# CITY OF TUCKER

ITB 2024-017

### TUCKER PICKLEBALL AND PARKING LOT CONSTRUCTION

## ADDENDUM #1

**C-400**

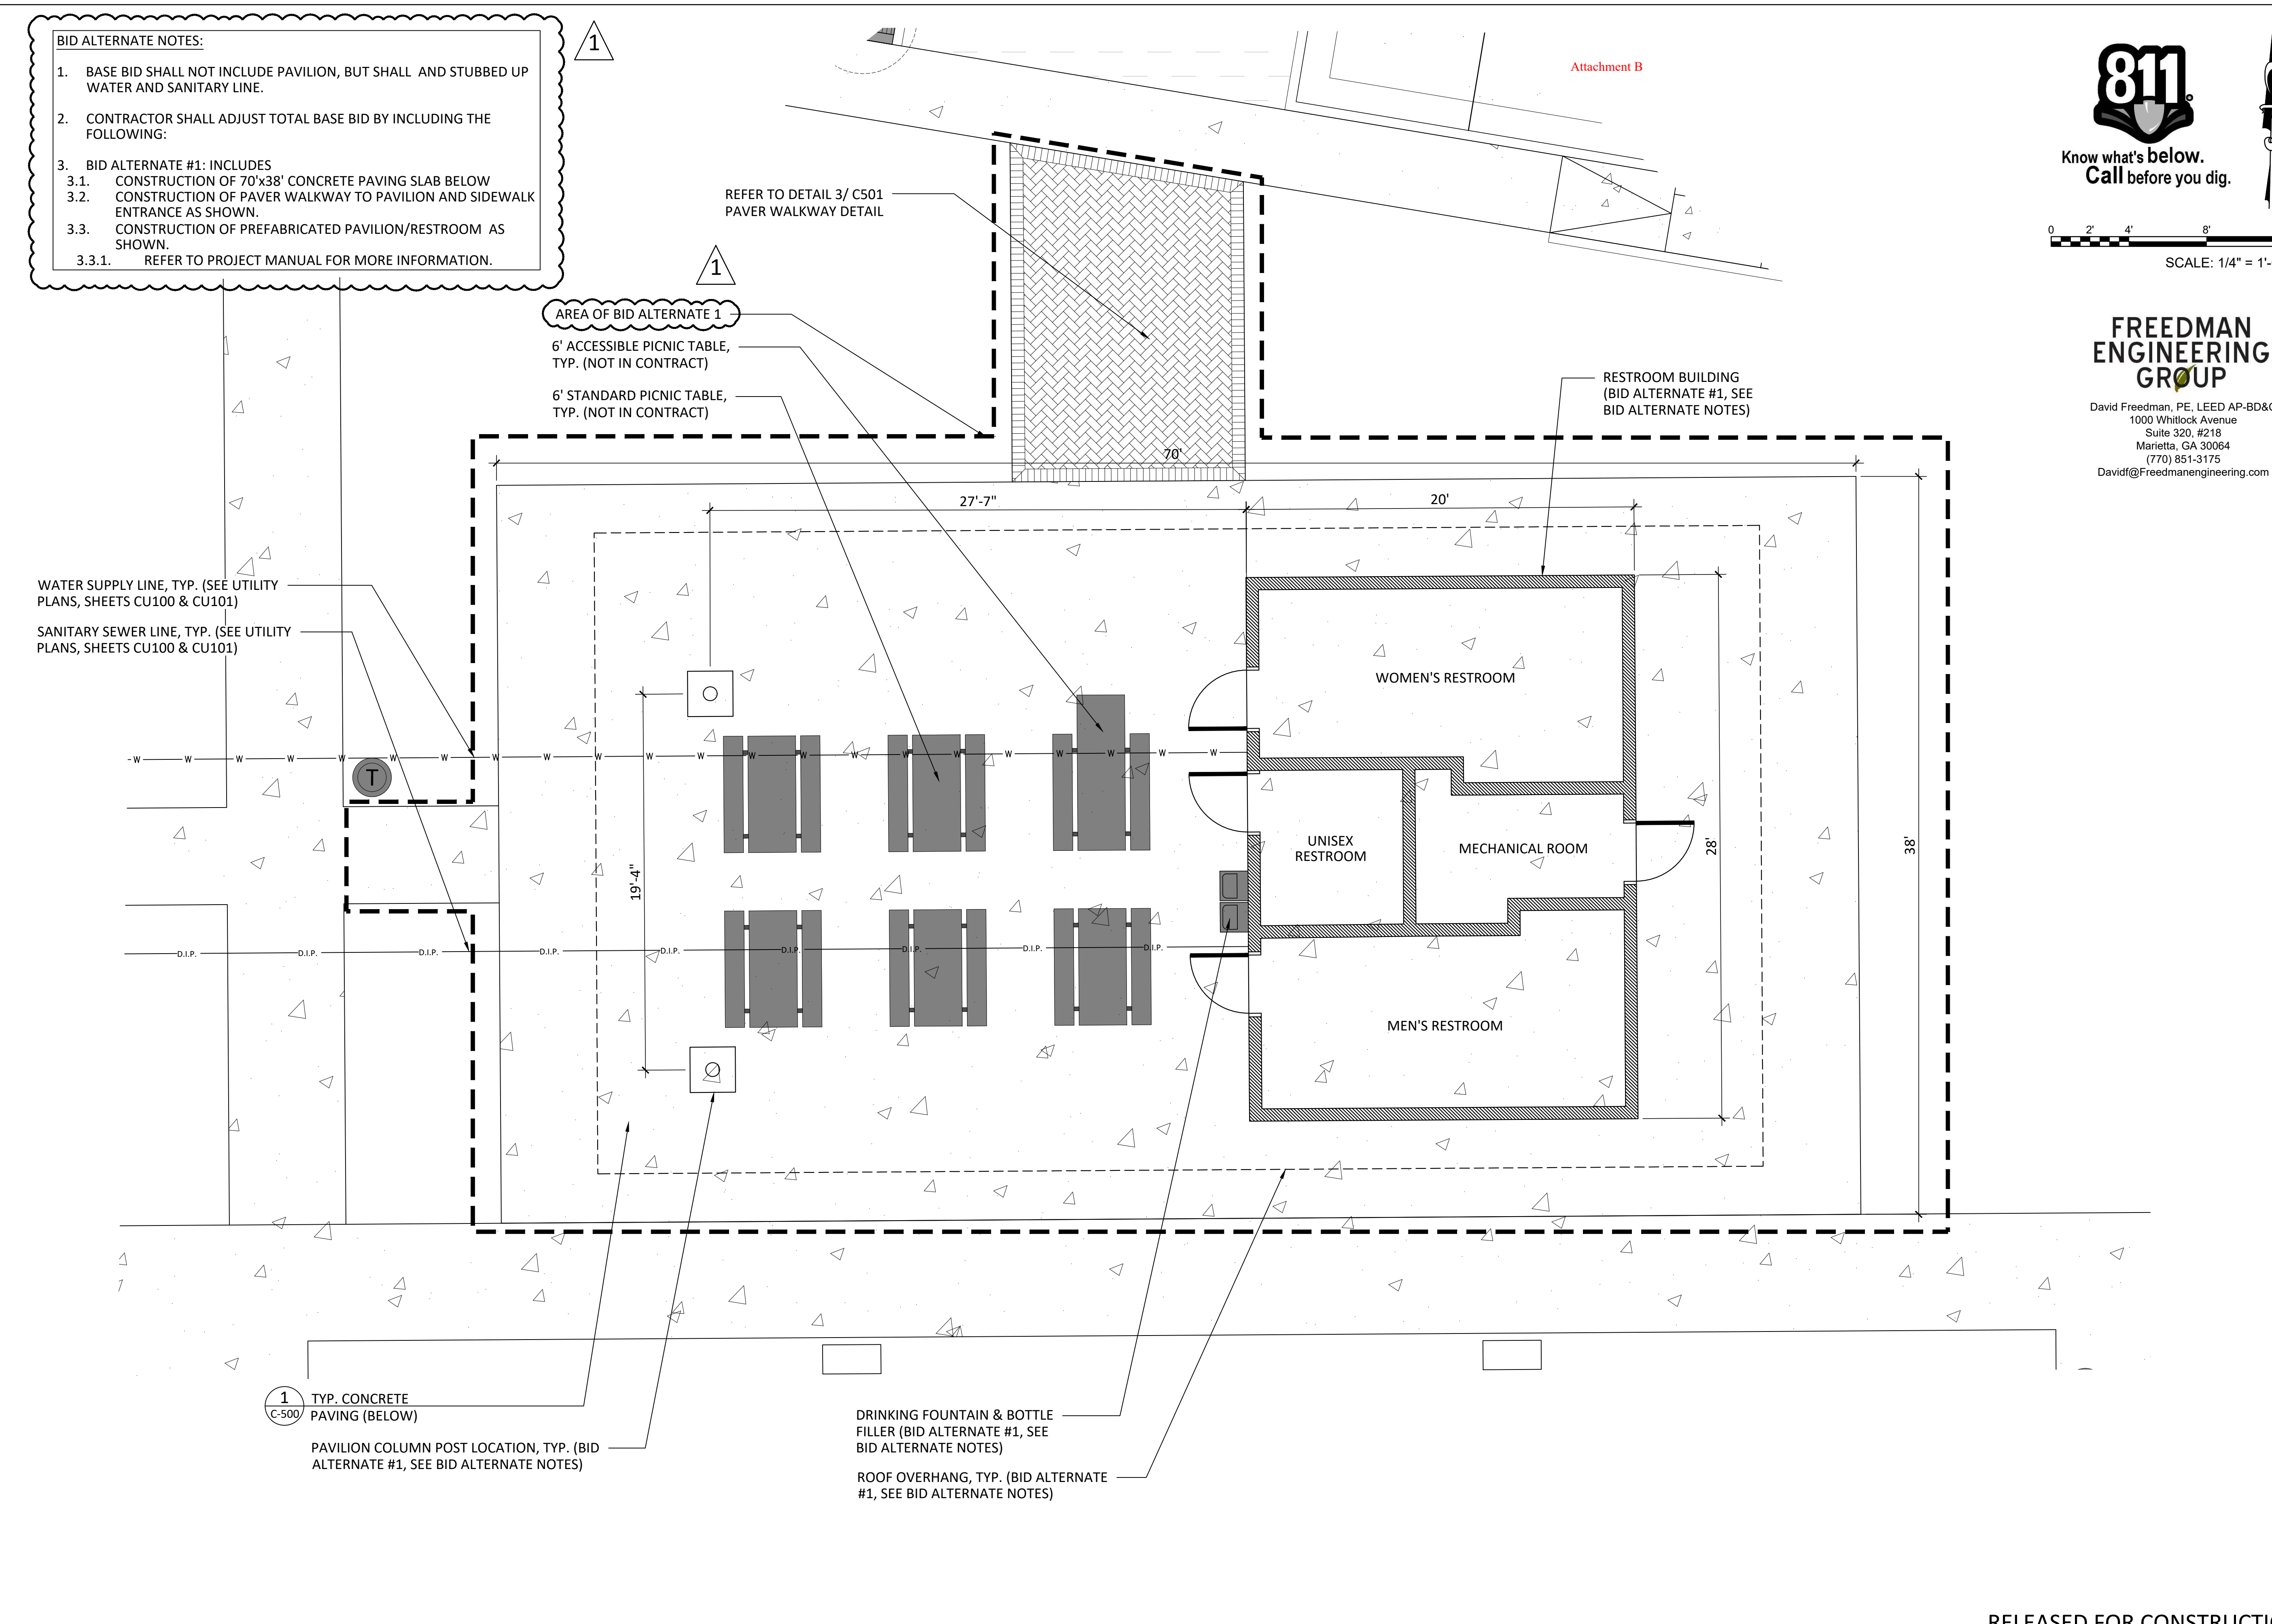
1. Sheet C-400: This sheet was revised to correctly reflect the base bid and alternate #1 bid work related to the pavilion and restroom building. Full size Sheet Attached.

1. BASE BID SHALL NOT INCLUDE PAVILION, BUT SHALL AND STUBBED UP WATER AND SANITARY LINE.
2. CONTRACTOR SHALL ADJUST TOTAL BASE BID BY INCLUDING THE FOLLOWING:
3. BID ALTERNATE #1: INCLUDES
  - 3.1. CONSTRUCTION OF 70'X38' CONCRETE PAVING SLAB BELOW
  - 3.2. CONSTRUCTION OF PAVER WALKWAY TO PAVILION AND SIDEWALK ENTRANCE AS SHOWN.
  - 3.3. CONSTRUCTION OF PREFABRICATED PAVILION/RESTROOM AS SHOWN.
    - 3.3.1. REFER TO PROJECT MANUAL FOR MORE INFORMATION.
